STATE OF MAINE  
DEPARTMENT OF TRANSPORTATION  
16 STATE HOUSE STATION  
AUGUSTA, MAINE 04333-0016

March 29, 2021  
Subject: Pavement Milling & HMA Overlay  
with Drainage & Safety Improvements  
State WINs: 023987.00 & 024587.00  
Location: **Yarmouth & Falmouth**  
**Amendment No. 1**

FALMOUTH  
LUNT ROAD  
TYPICAL SECTIONS

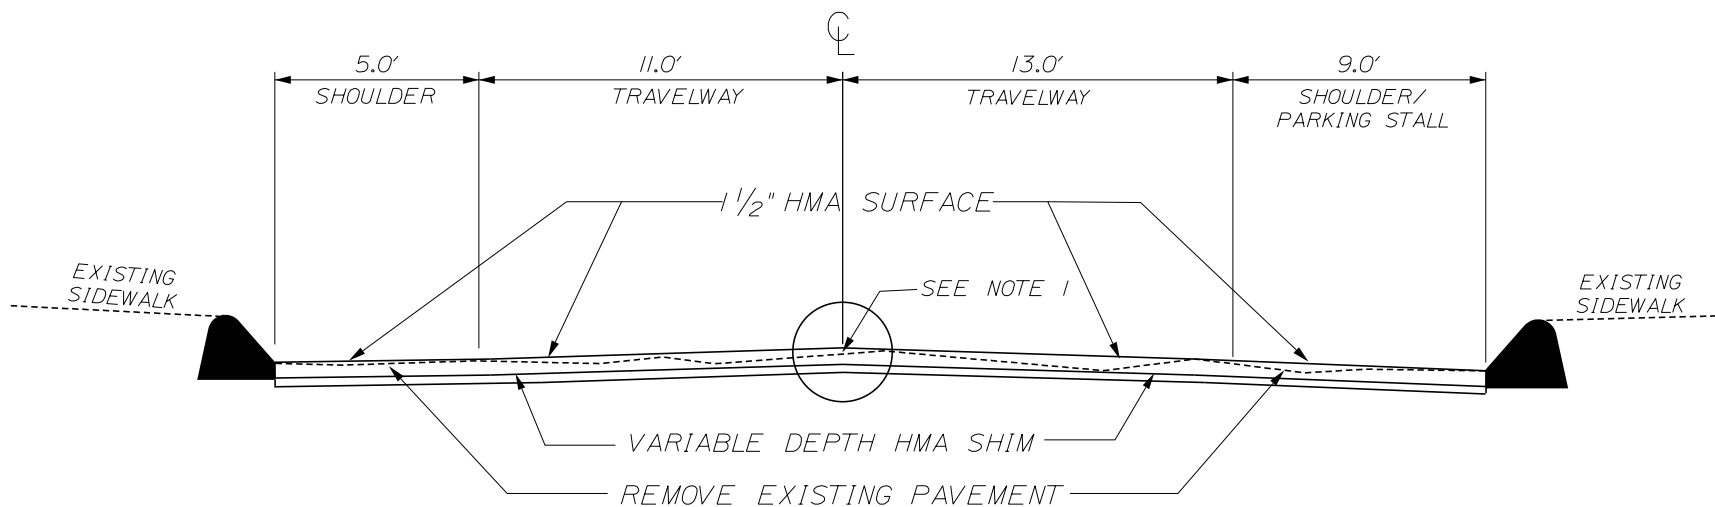
**REMOVE** pages 44 – 45, TYPICAL SECTIONS for WIN 23987.00, 2 pages and **REPLACE** with the attached TYPICAL SECTIONS for WIN 24857.00, 3 pages.

**Question:** The details for the Lunt Road section appear to be the details for the Route 115 project. Please supply correct details as soon as possible.

**Response:** See above changes.
